### **Proposed 30-Day Modifications to the Diesel Test Procedures**

# **CALIFORNIA EXHAUST EMISSION STANDARDS AND TEST PROCEDURES FOR 2004 AND SUBSEQUENT MODEL HEAVY-DUTY DIESEL ENGINES AND VEHICLES**

Date of Release: May 2021; Proposed 30-Day Notice  
Date of Hearing: August 27, 2020

**Figure CA26-1: Alternative Durability Demonstration Using Accelerated Aftertreatment Aging**

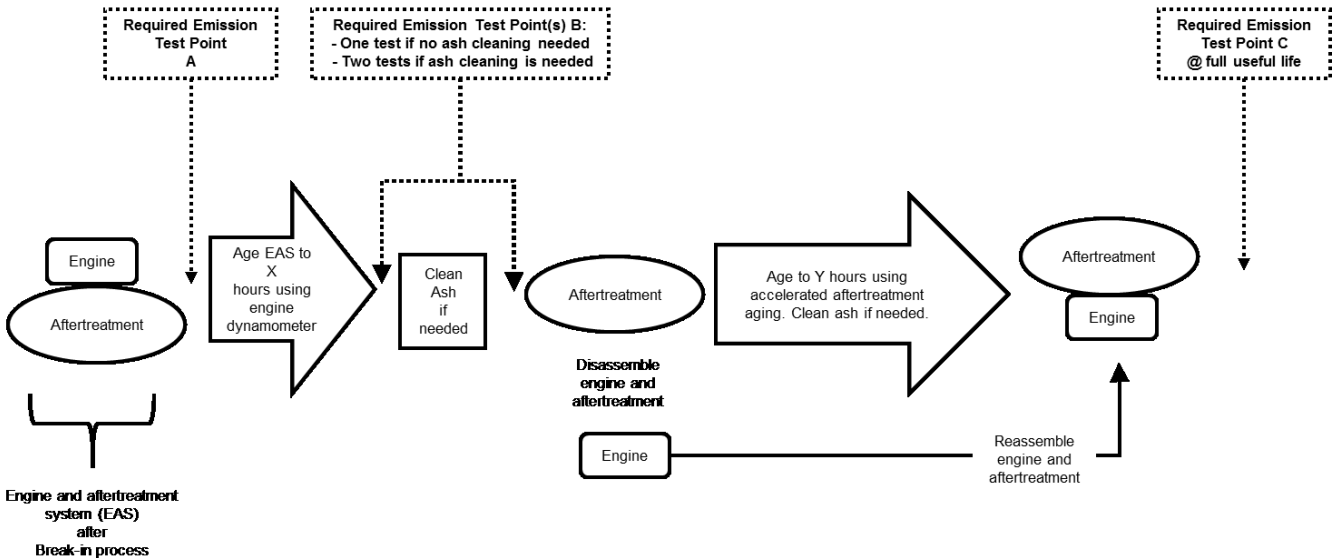
1.1.1.3.2 Option 2: 2,100 hours of service accumulation on an engine dynamometer, followed by accelerated aftertreatment aging for ½ of useful life, as shown in Figure CA26-1 below. In order to use this option, manufacturers must submit in-use emission data reports as described in subparagraph B.1.1.3 of this section for 50% or more of the medium heavy-duty diesel engines used in vehicles sold originally in California each and every year for three consecutive model years.

1.1.1.4.2 Option 2: 4,900 hours of service accumulation on an engine dynamometer, followed by accelerated aftertreatment aging for ½ of useful life, as shown in Figure CA26-1 below. This alternative durability demonstration program reduces the total hours of durability demonstration by allowing manufacturers to use accelerated aftertreatment aging for 50% of the useful life. In order to use this option, manufacturers must submit in-use emission data reports for heavy heavy-duty diesel engines for each and every year for three consecutive model years as described in subparagraph B.1.1.3 of this section.

1.1.1.4.3 Option 3: 3,000 hours of service accumulation on an engine dynamometer, followed by accelerated aftertreatment aging for 69% of useful life, as shown in Figure CA26-1 below. In order to use this option, manufacturers must submit in-use emission data reports as described in subparagraph B.1.1.3 of this section for 50% or more of the heavy heavy-duty diesel engines used in vehicles sold originally in California each and every year for three consecutive model years.

**Figure CA26-2: Two-Year Durability Demonstration Using Accelerated Aftertreatment Aging (Heavy Heavy-Duty Engines)**

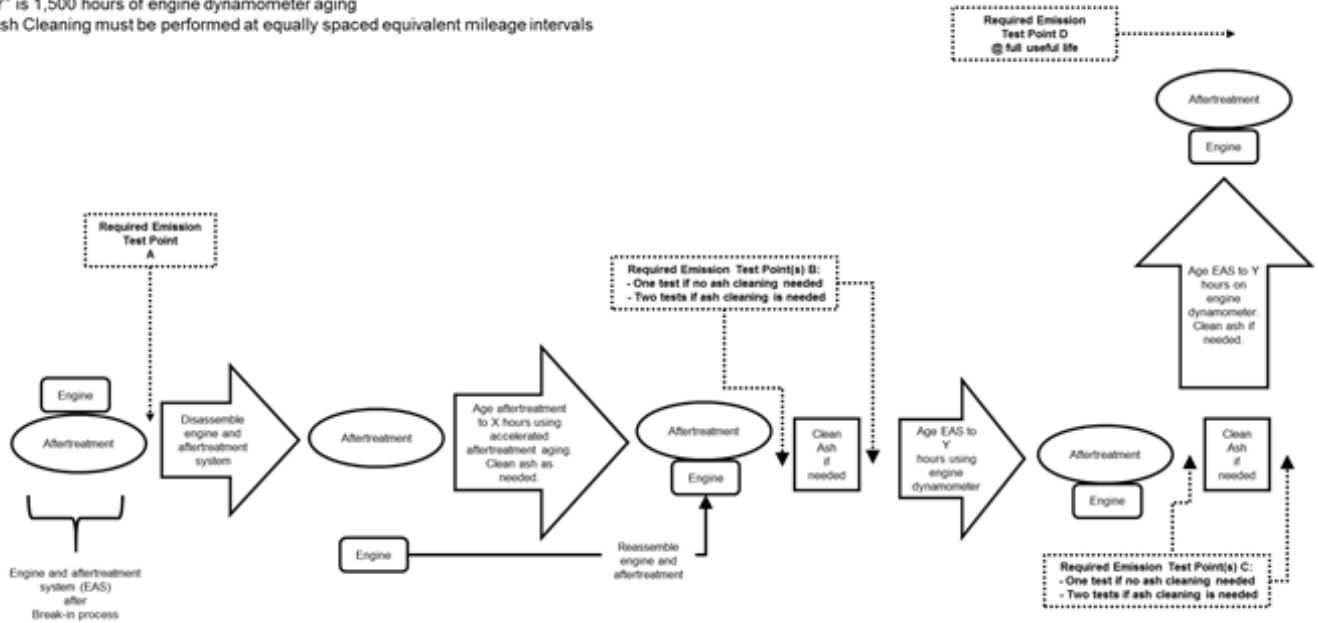
1.1.1.4.4.7 The sequence of engine dynamometer aging, accelerated aftertreatment aging, and the required emissions test points for this option are shown in Figure CA 26-2.

**Figure CA26-32: Cycle-1 Service Accumulation Cycle**

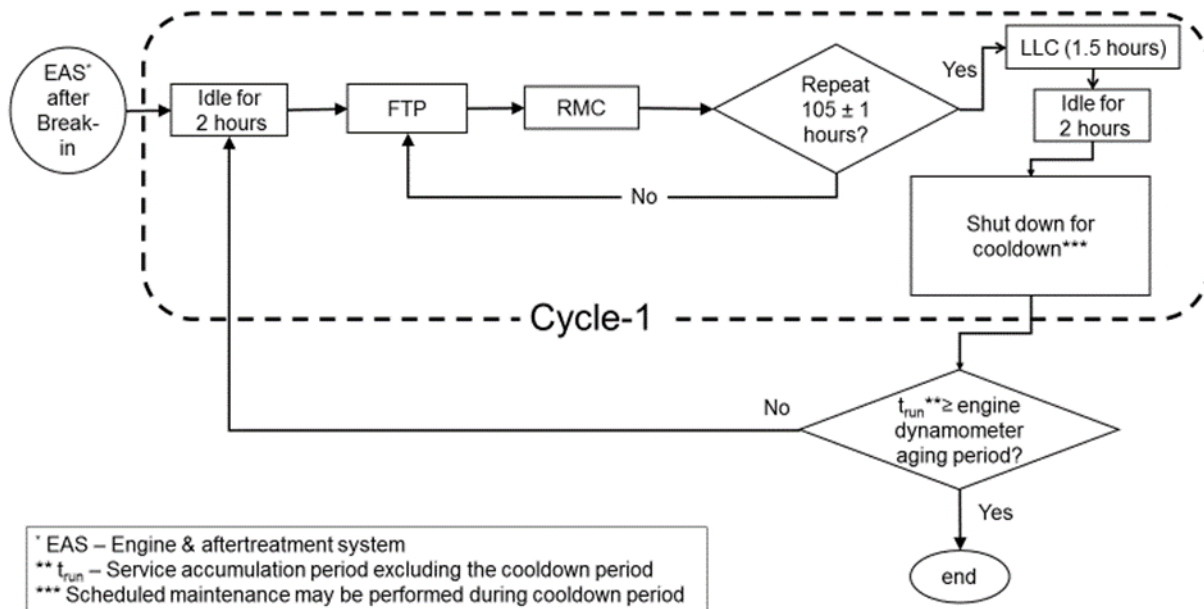
1.1.1.5.1 Cycle-1 – A combination of the FTP, RMC, LLC and extended idle periods as specified in Figure CA26-32.

**Figure CA26-43: Cycle-2 Service Accumulation Cycle**

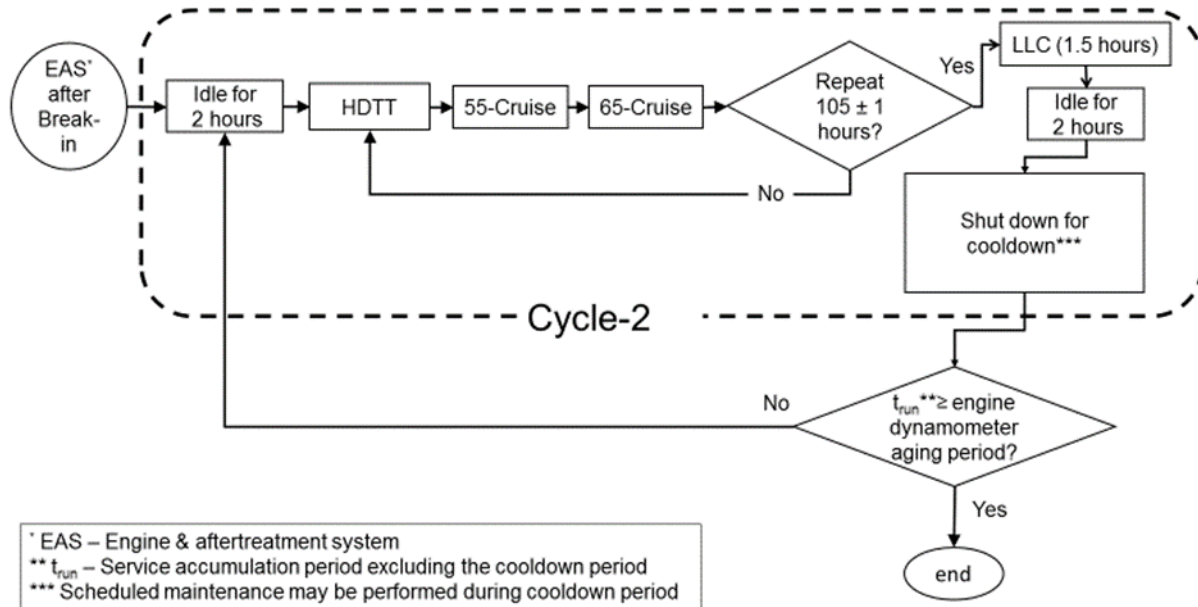
1.1.1.5.2 Cycle-2 – A combination of HDTT, 55-cruise, 65-cruise, LLC and extended idle periods as specified in Figure CA26-43. The manufacturer must consider all possible greenhouse gas vehicle subcategories as defined in 40 CFR §1037.230, last amended March 10, 2021 (Pre-publication) ~~Oct. 25, 2016~~, which is incorporated by reference herein. For each engine family, the manufacturer must choose the vehicle subcategory and vehicle configuration that yields the highest load factor using the GEM model. Manufacturers may use a 20-second ramp-up or ramp-down period in between the HDTT, 55-cruise and 65-cruise cycles. Engine manufacturers that do not have access to vehicle configuration parameters for the applicable engine family, may use vehicle design parameters used in the GEM model ~~(as specified in 40 CFR §1037.520, last amended October 25, 2016, which is incorporated by reference herein)~~ from previous model year engine families in the same primary intended service class and applications.

**Figure CA26-54: Alternative Durability Demonstration Using Accelerated Aftertreatment Aging for 2027 and Subsequent Model Year Heavy Heavy-Duty Engines**

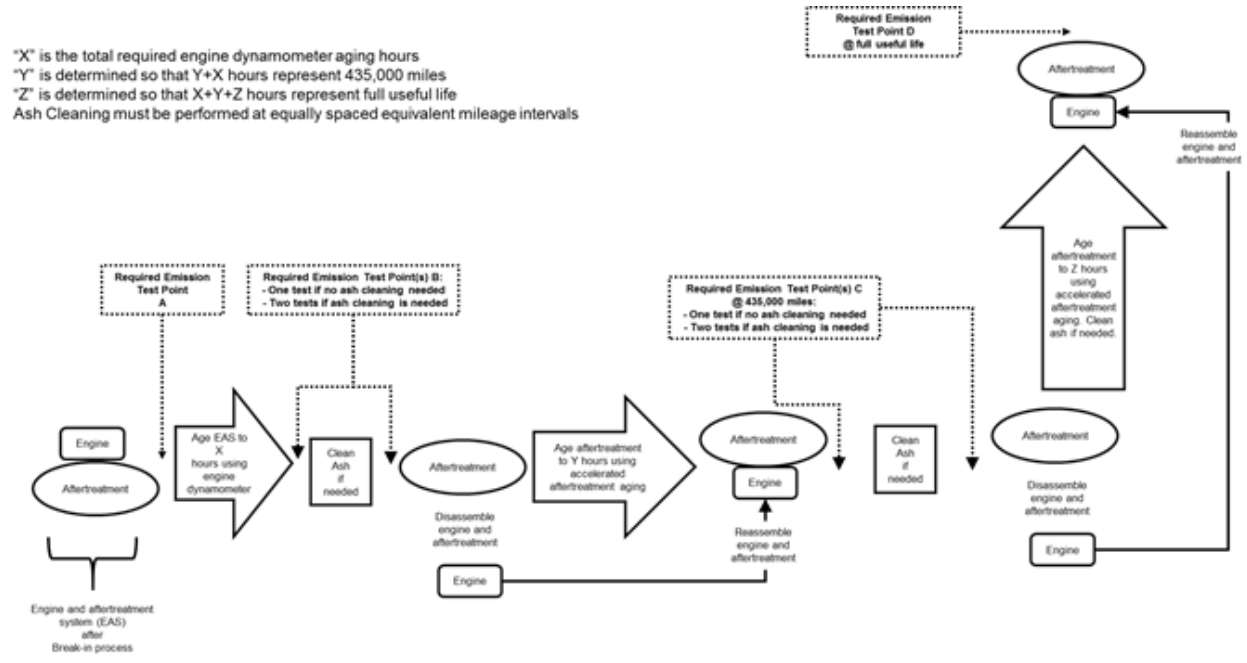
requirements in subparagraphs B.1.1.1.5 through B.1.1.1.7 of this section. For light heavy-duty and medium heavy-duty engines, the sequence of the aging process and the required emission test points are shown in Figure CA26-1. For heavy heavy-duty engines, the sequence of the aging process and the required emission test points are shown in Figure CA26-54. The following schedules establish minimum required service accumulation for each primary intended service class:
